Request for Class II Permissive Change(C2PC)

FCC ID: 2AULTEMA34GY-S

Date: 2025-5-26

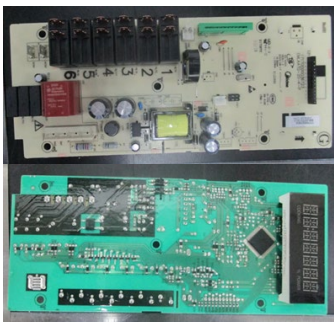
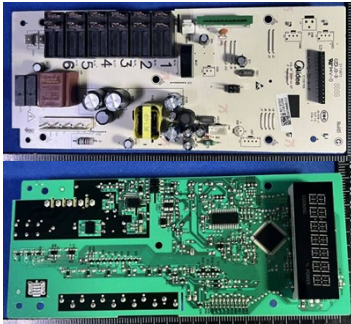
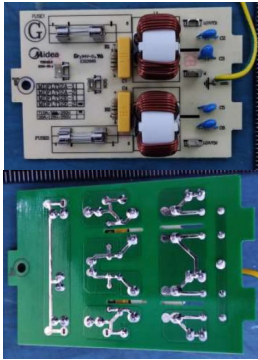
No.:	Original	New	Difference(s)
1			Mother board: Modified the peripheral circuit (non-RF circuit) and some individual components and PCB layout. The magnetron and other circuit are exactly same as before.
2			Filter board: Changed the Y1 capacitor of C5, C2 and C6 to 1000pF 400VAC, and changed the Y1 capacitor of C3 to 470pF 400VAC.
3	N/A		Add a USB interface.
4			Updated front keypad (added the USB function).
